ALERT SERVICE BULLETIN

NO. 206L-09-158

MODEL AFFECTED: ALL 206L SERIES HELICOPTERS

SUBJECT: AIRWORTHINESS INSPECTION LIMITATION TO TAILBOOM LEFT UPPER ATTACHMENT FITTING P/N 206-032-409-001.

FIGURE 3: REPLACEMENT OF LOOSE (WORKING) RIVETS IN TAILBOOM ATTACHMENT FITTING P/N 206-032-409-001

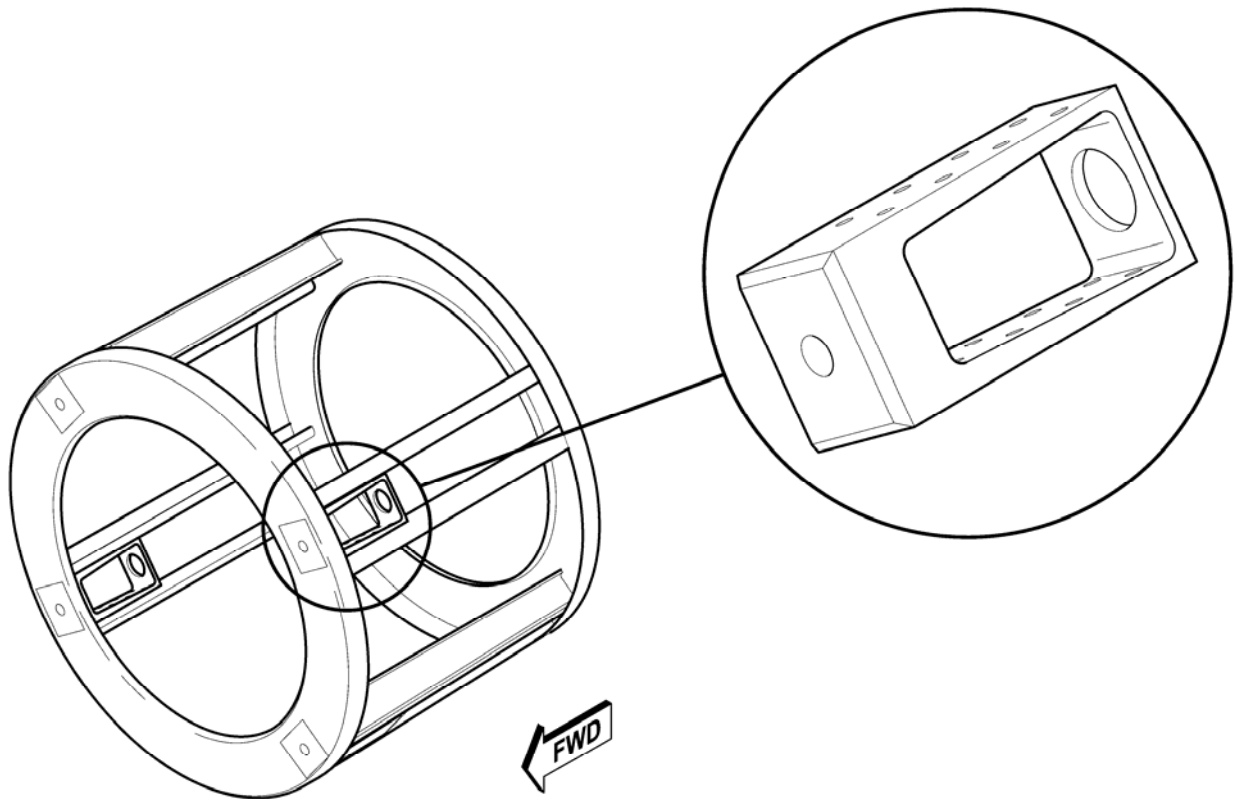
- f) (Ref. Figure 3) Whenever one original 5/32 fasteners needs oversize replacement, all the rivets in that affected rivet group (Group "A", "B" or "C") are to be replaced with the same type and size of oversize fastener.

- g) It is acceptable to have a mix of "DD" and "E" type rivets in the same leg of the fitting as shown as group "D" but it is not acceptable to have such a mix within rivet respective groups "A", "B" or "C".

Example 1: (Ref, Figure 3) A rivet hole in part of group "A" is elongated (oversize); both rivets in group "A" must be replaced.

Example 2: (Ref. Figure 3) Two rivet holes, one in group "A" and the other in group "B" are elongated (oversize); all rivets in both groups ("A" and "B") must be replaced. Although the rivets in group "C" do not require to be changed, it is acceptable if the operator chooses to replace those as well.

When different type or size of rivets from factory original are required due to hole(s) beyond the limit of Table 3-4 of the SRM where oversize rivet(s) is/are needed, any number of different type or oversize rivets can be installed provided the following restrictions are met:

- a) Either MS20470DD or MS20470E rivet type may be used as replacement. Only these two can be used.
- b) A minimum of 2D edge distance shall be maintained on all rivets replaced.

- c) 4D minimum pitch shall be maintained between all rivets.
- d) No rivet bigger than 3/16 diameter are allowed in any leg of the fitting.
- e) No rivets shall interfere with the installation of the hardware securing the tailboom assembly to the fuselage.

- f) No rivets should be located in the radii of the fitting.
- g) Whenever one original 5/32 fasteners needs oversize replacement, all the rivets in that affected rivet group (Group "A", "B" or "C") are to be replaced with the same type and size of oversize fastener.

- h) It is acceptable to have a mix of "DD" and "E" type rivets in the same leg of the fitting as shown as group "D" but it is not acceptable to have such a mix within rivet respective groups "A", "B" or "C".

Example 1: A rivet hole in part of group "A" is elongated (oversize); both rivets in group "A" must be replaced.

Example 2: Two rivet holes, one in group "A" and the other in group "B" are elongated (oversize); all rivets in both groups ("A" and "B") must be replaced. Although the rivets in group "C" do not require to be changed, it is acceptable if the operator chooses to replace those as well.

FIGURE 1: INTRODUCTION OF AIRWORTHINESS INSPECTION LIMITATION TO TAILBOOM ATTACHMENT FITTING P/N 206-032-409-001

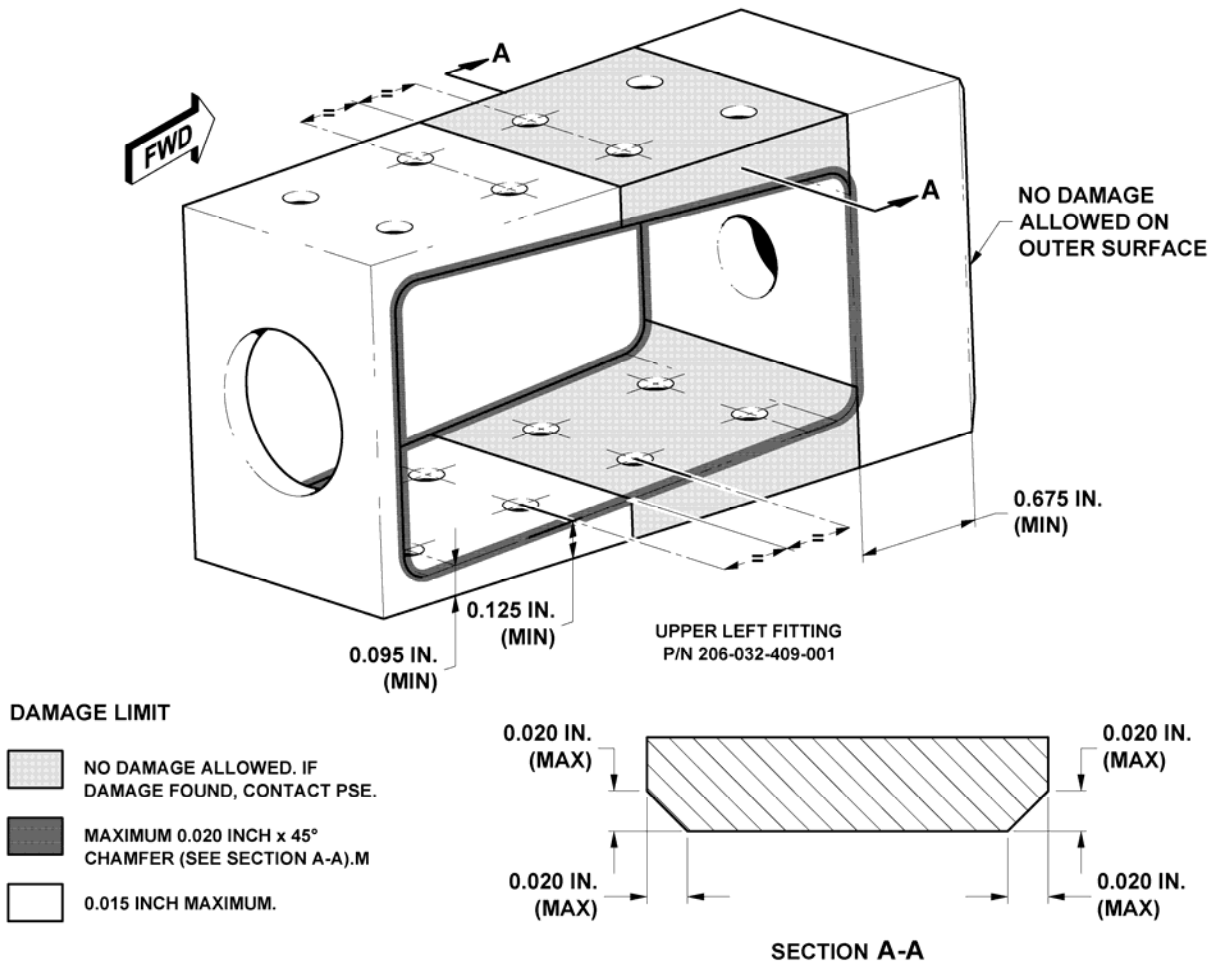
2. (Ref. Figure 1) Clean the complete tailboom attachment area with aircraft soap (C-318) prepared in accordance with manufacturer's recommendations to remove all traces of dirt, stains, exhaust residues and oil. Rinse with water and let area to dry.

1. Inspect upper left attachment fitting P/N 206-032-409-001 for a crack, corrosion, loose rivets, mechanical damage and general condition within a period not to exceed 100 hours of flight time.
2. Repair fitting in accordance with **PART I** and Figure 2 provided limitations are met after rework.
3. Replace cracked or damaged fitting or loose rivets in accordance with **Part II** of this bulletin.
4. Tailboom assembly remaining details not shown for clarity.
5. If a crack is found, contact Product Support Engineering with details using the following information;

FIGURE 2: DAMAGE LIMITATION AND APPROVED REPAIR TO FITTING P/N 206-032-409-001.

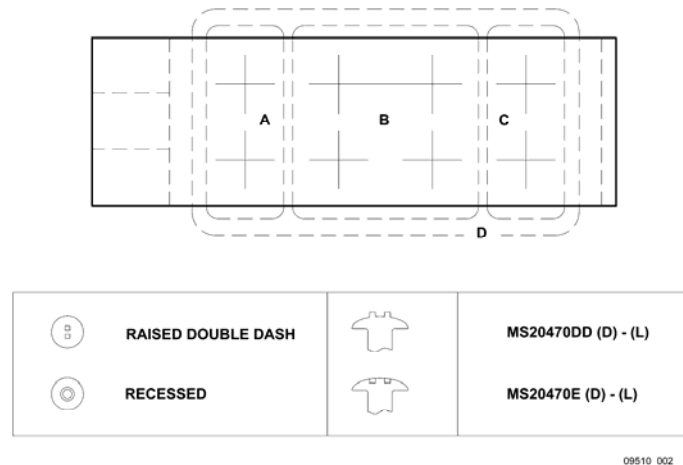
3. (Ref. Figure 2) Use a bright light source with a mirror and inspect visually the left upper tailboom attachment fitting P/N 206-032-409-001 for loose (working) rivets, corrosion, condition and mechanical damage. Pay close attention on each leg of the fitting for a crack near the two most forward vertical rows of rivets.
4. If a crack, loose (working) rivets, is found on upper left attachment fitting, accomplish **PART II** of this bulletin.
5. If corrosion or mechanical damage is found on the fitting, refer to FIGURE 2 to determine if the fitting can be repaired.
 - a) If damage is beyond repairable condition, replace the fitting in accordance with **PART II**.
 - b) Repair acceptable damage as follows;

Depth of repair shall be twice the depth of corrosion not to exceed the repair limits of Figure 2.

- i. Blend the damage on the fitting in order to remove minimum material. A 20:1 width to depth ratio should be maintained.
 - ii. If damage is affecting the corner radius area of the fitting (see double-hatched area), blend to obtain minimum chamfer that will remove the damage. A maximum of 0.020 inch (0.508 mm) X 45° chamfer is allowed.

- Clean the fitting to remove all dirt or debris before inspection.
- Blend the fitting smooth in order to remove any corrosion or mechanical damage. Care shall be taken to prevent increasing the depth of the damage. A 20:1 width to depth ratio shall be maintained.

- Removal of corrosion shall be twice the depth measured, not to exceed the limitations shown.
- Perform the minimum chamfer required to remove the damage and to ensure subsequent blending provision in case of future damage. Maximum 0.020" x 45° chamfer allowed.

- Surface finish after blend to be 32 RMS or better.
- Perform a fluorescent penetrant inspection of the reworked areas per instructions detailed in BHT-ALL-SPM to ensure that the damages were fully removed.

- Clean the fitting to remove fluorescent penetrant.
- Measure the amount of material removed from the fitting in the reworked areas. The maximum amount of removed material to be within the above figure limitations. If this condition is not met, resubmit to PSE for evaluation.

- Perform brush chemical film application to bare metal following instructions detailed in BHT-ALL-SPM.
- If required, prime the reworked areas using primer per MIL-P-23377.
